Access Compliance Report

Public Rights-of-Way

(Pedestrian Signals)

Intersection ID: N/A	Main Street:	Cross Street: N/A	Location: N/A
ADA ID: 2D3857866D0F	Signal Type: One Push Button-APS	Overall Compliance: No	Severity Score: BTN 1: N/A BTN 2: N/A No BTN: N/A
Codes/Mitigation Info/Possible Solution		Field Measurements/Component Compliance

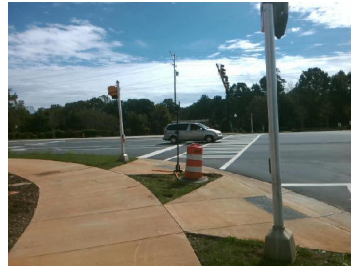
Surveyor Notes: OUT OF SERVICE

PROW/ADA: R404.2, R406.2, R404.7.3,
R209.1, TMUTCD 4e.10, MUTCD 4e.08,
R104.2,

Possible Solutions: Remove & Replace
Replace APS Button With New APS Button.
Remove and Replace Clear Space.
